BeoSound 3000 » Software version history

BeoSound 3000

Software 3.0 in products with serial no. lower than 15955832:

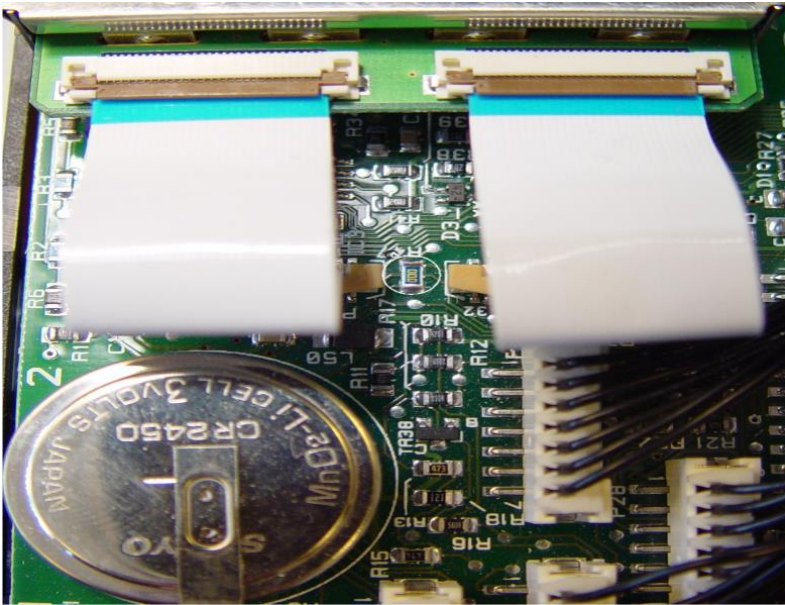
- Replace software to software version 3.0.
- Mount a jumper at position 2R47 between the flat cable plugs:

In serial nos. lower than 14923175 PCB89 can be modified:

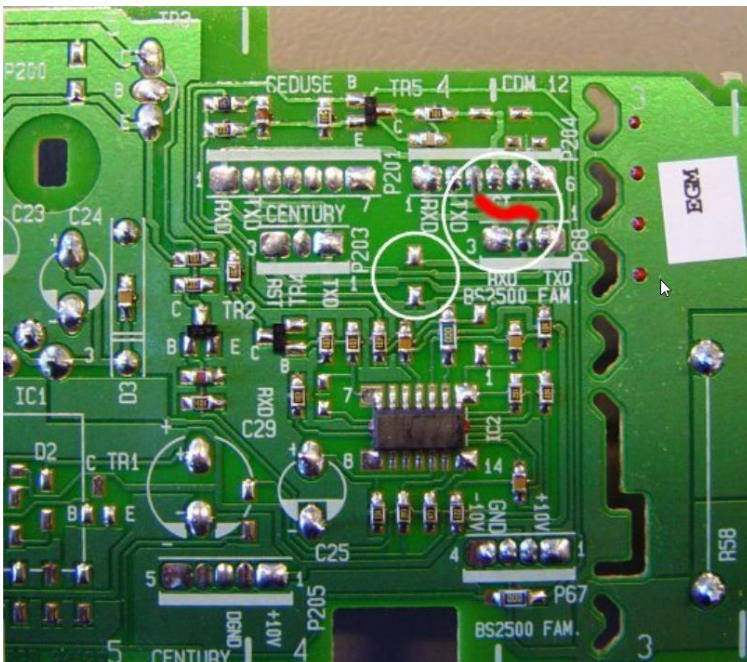
- Mount CD PRO II
- Remove jumper
- Mount an insulated wire between 89P204-3 and 89P68-2
